I-70 Floyd Hill to Veterans Memorial Tunnels

Appendix B

Comments Received

Open Space Commission Map of Hidden Valley Open Space Park

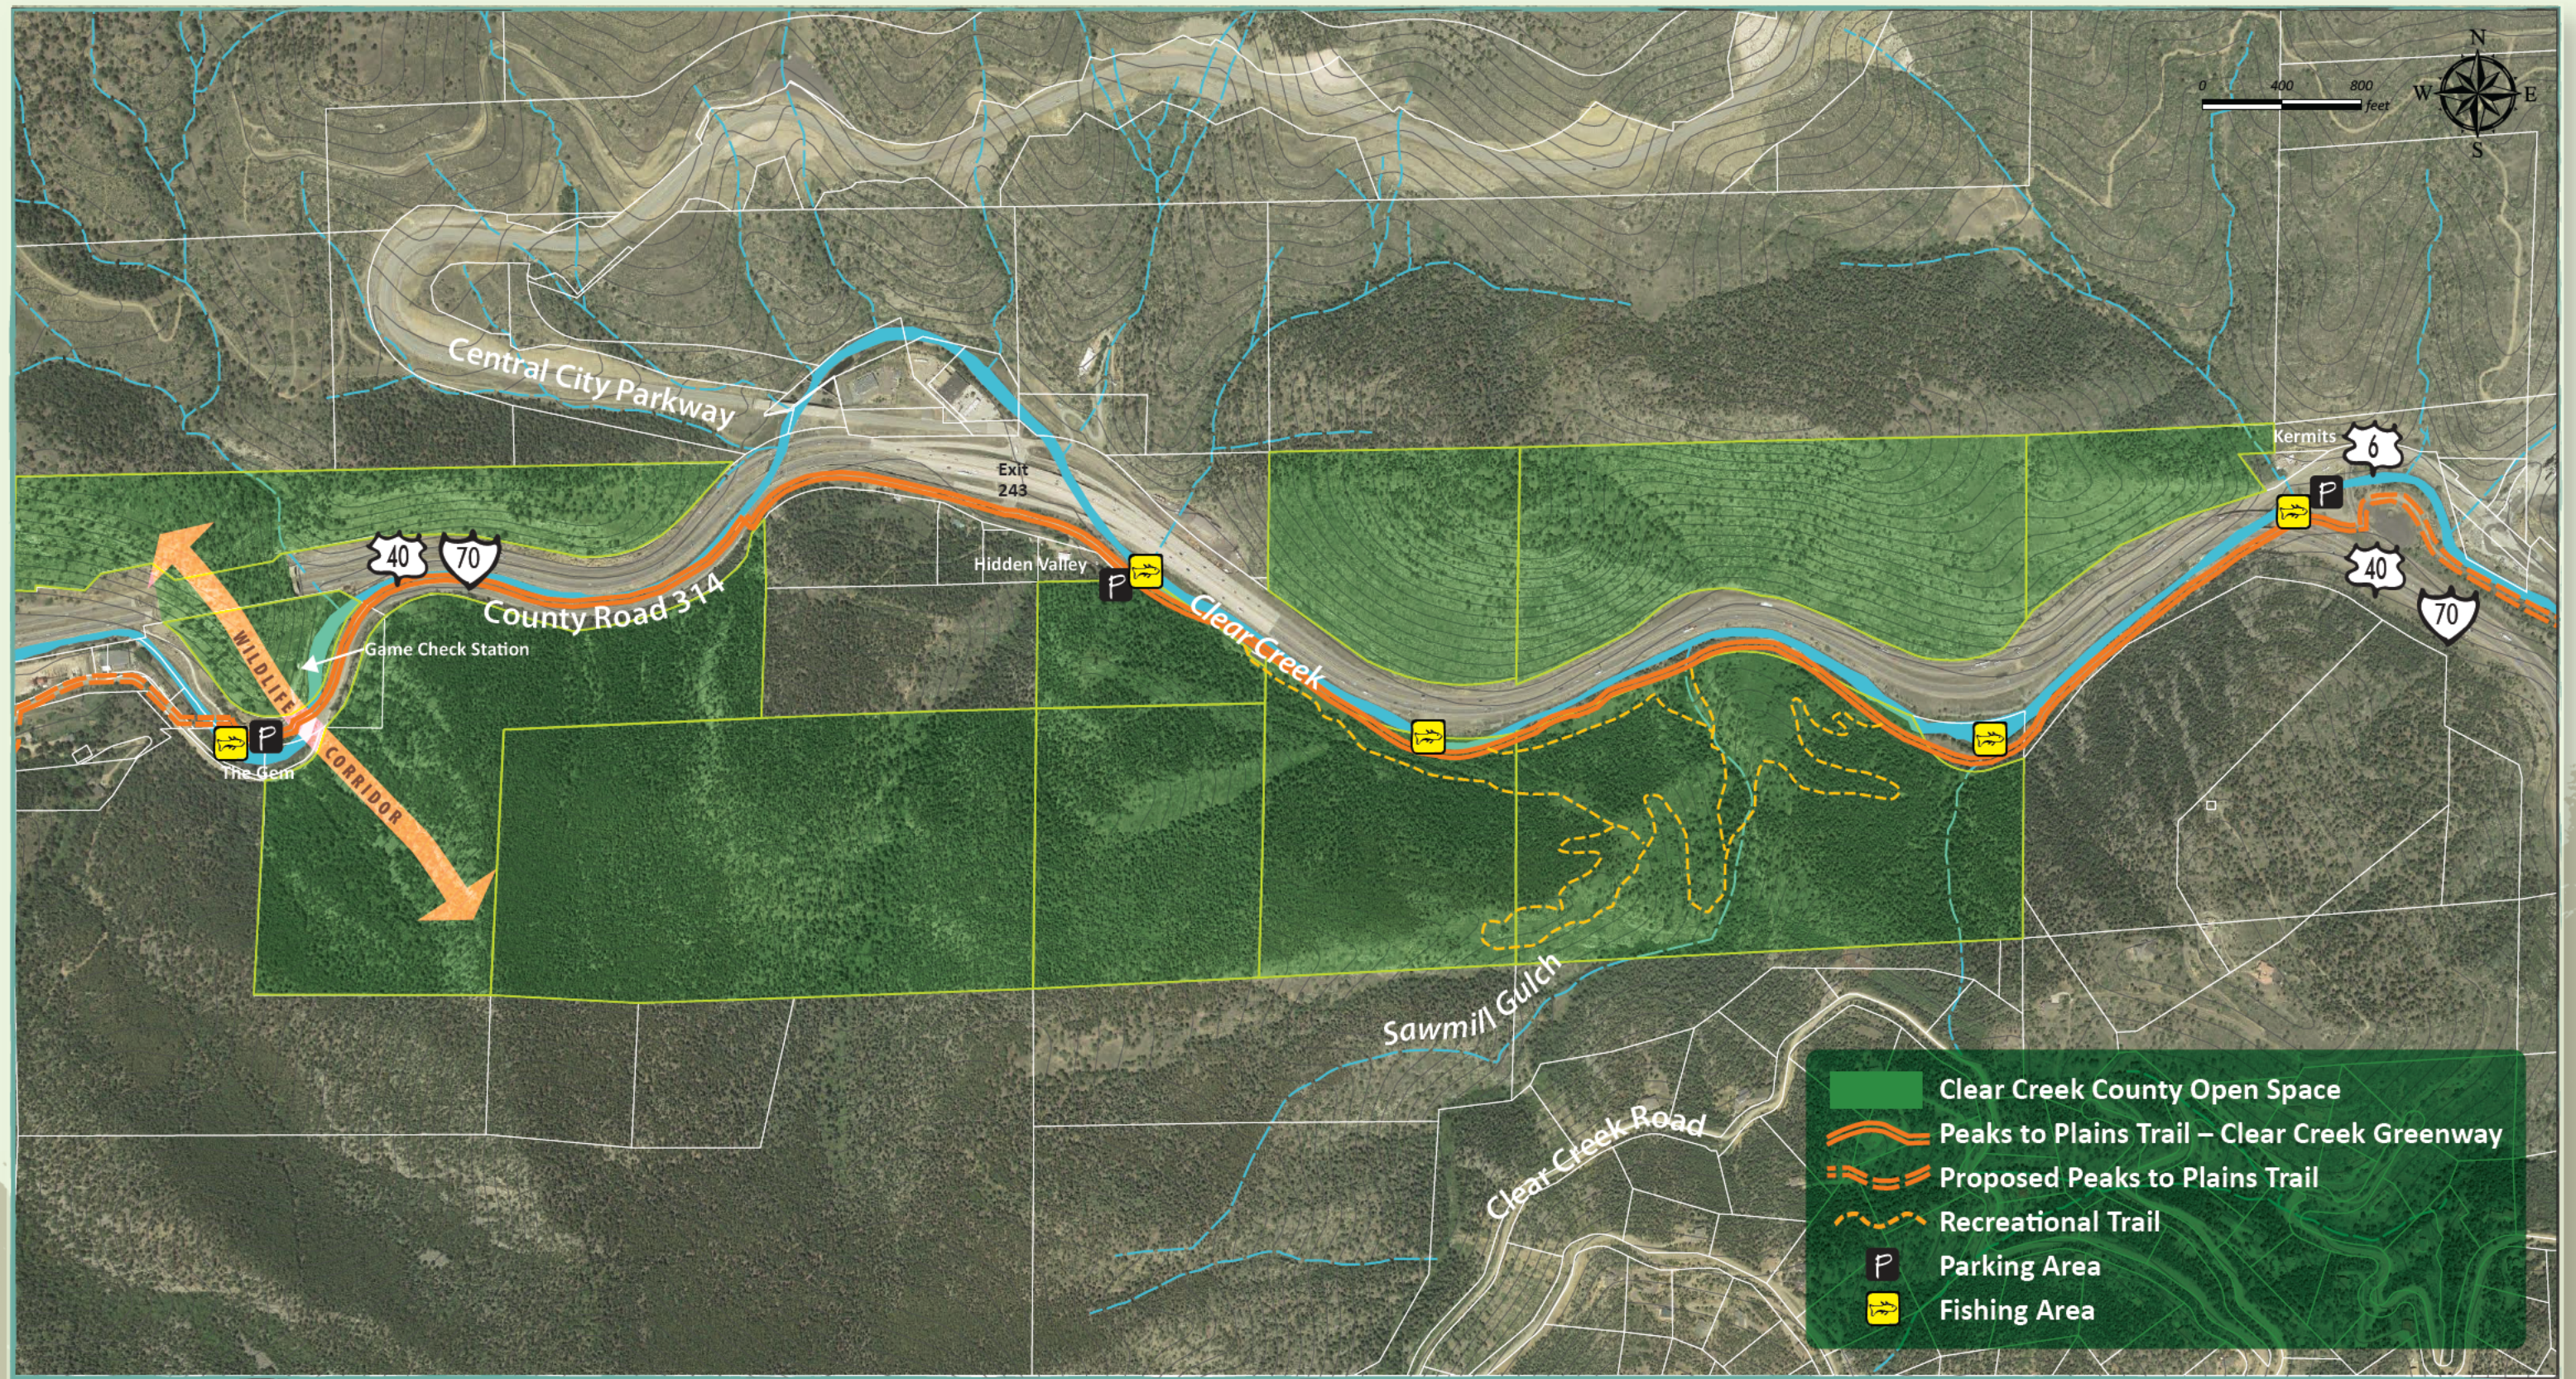
Thank you for your letter on December 8, 2020 in response to the Clear Creek County concerns with the impact of the South Frontage Road option of the Floyd Hill project on historical and recreational resources in the Hidden Valley Open Space Park. Clear Creek County continues to maintain that the South Frontage Road option renders historical interpretation and recreational activities impossible in the park: 1) creating an adverse impact to an eligible historic resource under Section 106 of the National Historic Preservation Act (NHPA)(16 U.S.C. 470) and its regulations at 36 CFR § 800; and 2) constituting a violation of Section 4(f) of the U.S. Department of Transportation Act of 1966 (49 U.S.C. §303 and 23 U.S.C. §138) and its regulations at 23 CFR 774. Clear Creek County is considered a consulting party under the NHPA. And, as owner of the subject public park and recreation area, the county is considered an official with jurisdiction under Section 4(f) thus requiring coordination with the County and requiring the County's written concurrence of a finding of no adverse effects prior to making a "de minimis" impact findings (23 CFR 774.5(b)). Clear Creek County does not concur with the agencies' findings with respect to NHPA and 4(f).

Point 2 in your letter asserts that “the trail itself would not change alignment under the alternatives.” That is false. The trail, the Colorado Peak to Plains Regional Trail/Clear Creek Greenway, currently sits in the middle of the railbed with ample space (10 -15 feet) between each the trail and mountainside with the historical walls on the south, and the trail and Clear Creek on the north. The trail itself is 10-foot-wide and occupies the center of the railbed making it quite evident that the biker or hiker is on a previous transportation corridor. According to the visual simulations of the South Frontage Alternative, and the 30% design plans provided by CDOT, a frontage road would be at least 30 feet wide, more than the width of the railbed. The 10-foot trail would be pushed to the extreme edge of the creek, as a 5-foot distance is required from 30 feet of “frontage road.” The proposed frontage road and trail create a 45-foot swath which destroys not only the entire railbed but also the accompanying historic walls which, according to the CDOT visual simulation, will be replaced by a concrete retaining wall on the mountainside. To simply say “(it) would be closer to the frontage road” is erroneous. Further, the “frontage road” referenced in your response is not designed as a mere frontage road. It is designed as the westbound extension of Highway 6. Every truck headed west on Highway 6 or from the Frye Quarry must use that road. The trail will exist as an attachment to a very busy highway extension. The Railroad Corridor contributing segment will be eliminated. Each time a smaller, but very visible segment is destroyed, the integrity of the National Register resource is diminished, which constitutes an “adverse impact” As a consulting party under the NHPA, the County has made the jurisdictional determination that the South Frontage Road alternative will have an adverse impact on the eligible cultural resource.
